PRE-APPLICATION CONFERENCE
LOCKWOOD MEADOWS SUBDIVISION (2019-PAC)
 Meeting conducted on Tuesday, March 19, 2019 – 2:00 PM

Site Address	2000 NE Lockwood Creek Road, La Center, WA 98620
Legal Description	#94 SEC 2 T4N R1EWM 20A; PIN 209113000
Applicant	Matthew Vissotzky, The Holt Group, Inc. PO Box 61426, Vancouver, WA 98666 Contact: 360-220-5354 matthew@hotgroupinc.com
Applicant's Representative	AKS Engineering & Forestry LLC, 9600 NE 126 th St, Ste 2520, Vancouver, WA 98682. Contact: Dave Weston 360.882.0419, davew@aks-eng.com
Property Owner	Patricia Kay Reed, 2000 NE Lockwood Creek Rd, La Center, WA 98629.
Comprehensive Plan / Zoning	Urban Low (UL) / Clark County R1-7.5; Urban Holding (UH) 10
Proposal	Annexation. Subdivide approximately 20 acres into 71 detached single-family residential lots. Access is proposed off the following streets: E 4 th Way, E Upland Ave and NE 24 th Avenue. Critical areas are present.
Applicable Regulations	La Center Municipal Code (LCMC) Titles: 3.35 Impact Fees; 12, Streets, Sidewalks & Public Ways; 13, Public Utilities; 15, Buildings and Construction, and the La Center Comprehensive Plan. Applicable Title 18 requirements include chapters: 18.30 Proc

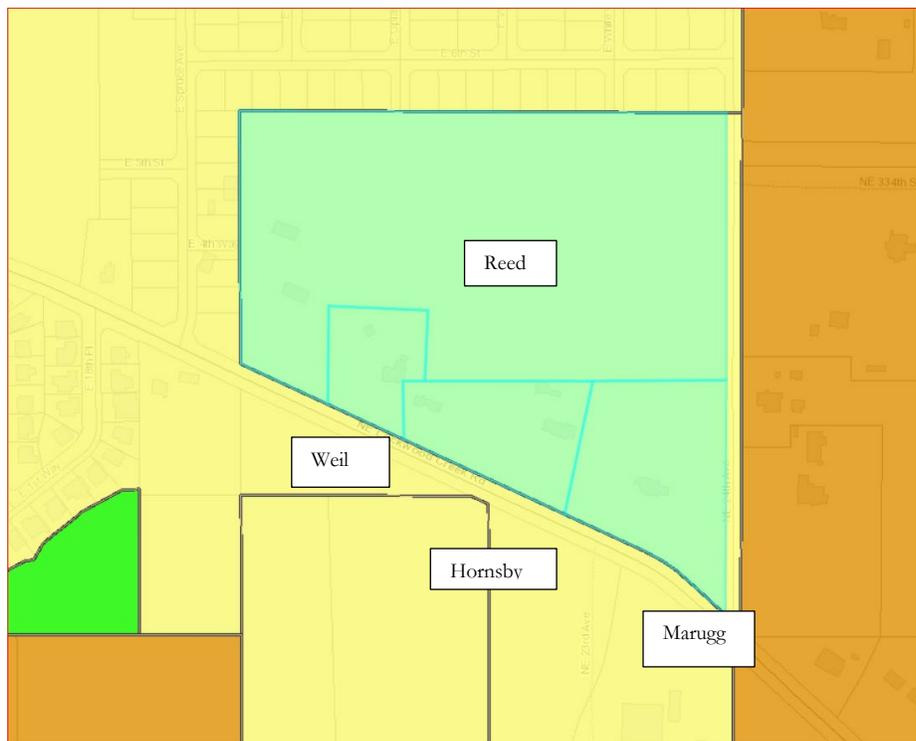
Four properties are located within the La Center UGA at the intersection of Lockwood Creek Road and NE 24th Ave. The city will consider annexation of all four properties concurrently rather than one at a time.

Annexation requires an analysis of capital facilities (Sanitary sewer, water, transportation, schools, and parks) necessary to serve the subject land and a finding that facilities are available or are planned and funded with the intent to be available within 6 years. Because of the need for an integrated approach to capital facilities in this area which is constrained by topography, critical areas and existing and planned infrastructure, the city will consider annexation of the remaining 29.79 acres of the UGA at one time. The city will not consider piecemeal annexation requests.

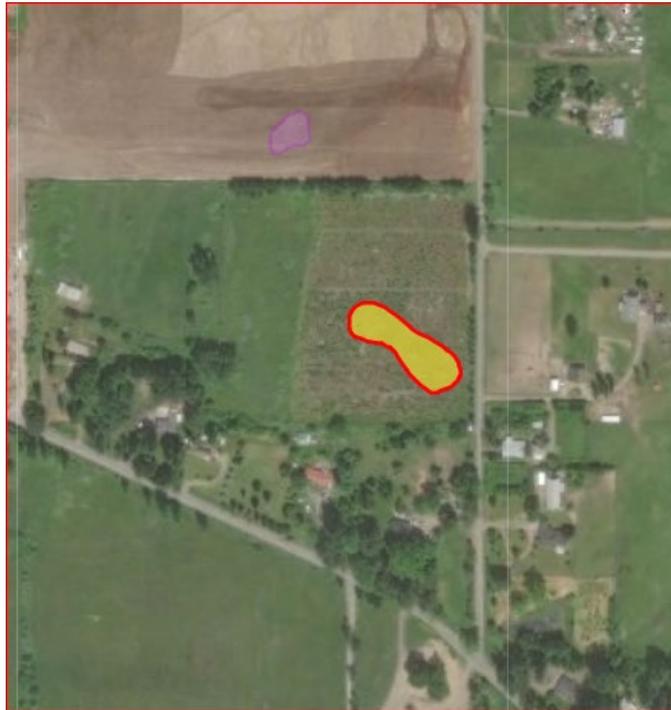
The applicant states GIS indicates a perennial, non-fish-bearing stream and three (3) wetlands on site. The large wetland in Tract A appears to be part of a stream system. The applicant proposes to fill approximately 0.34 acres of wetland and to reduce the buffer of Tract A wetland.

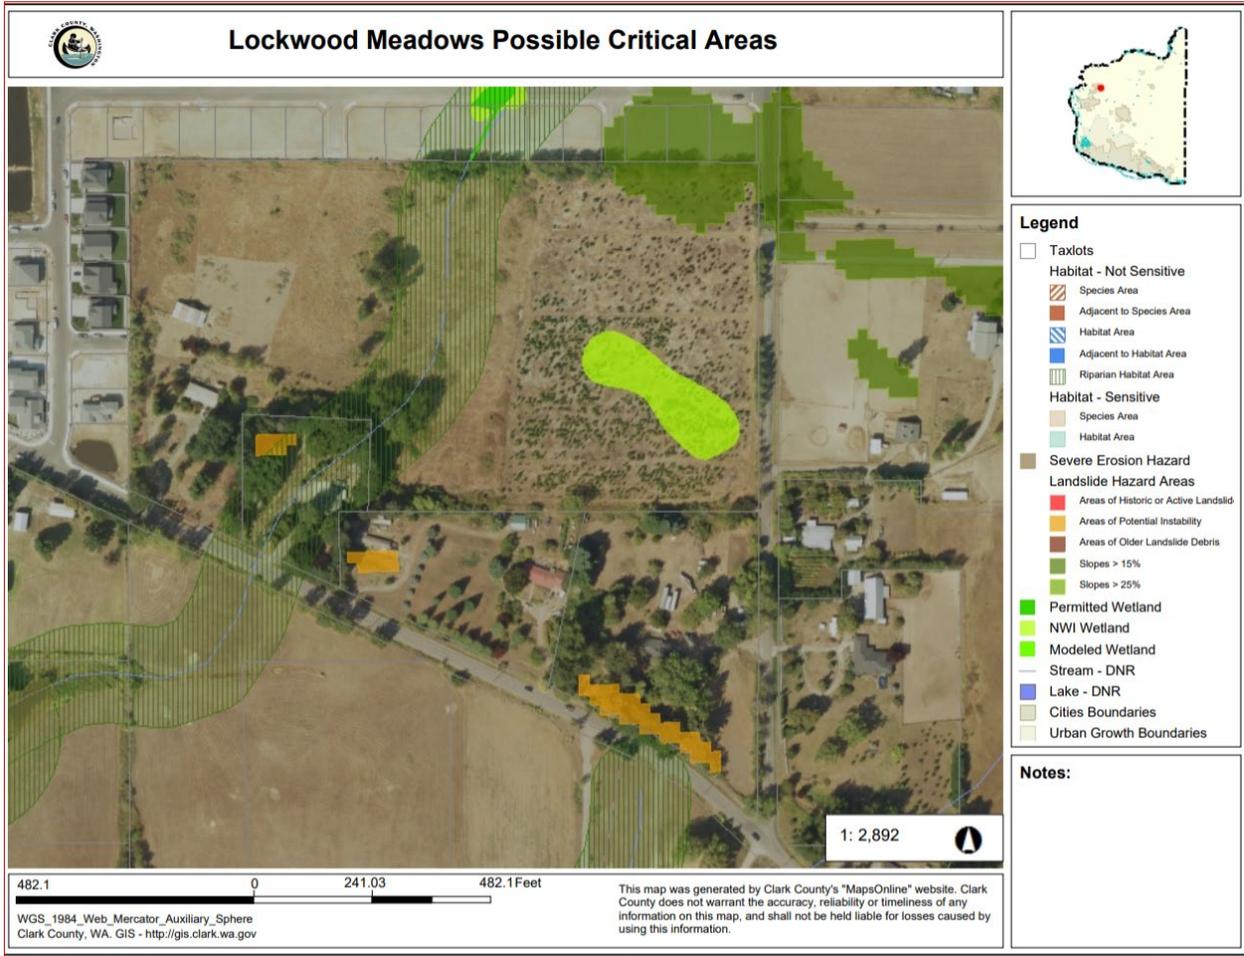
The Washington Department of Fish and Wildlife (WDFW) indicates the presence of an emergent wetland on site.
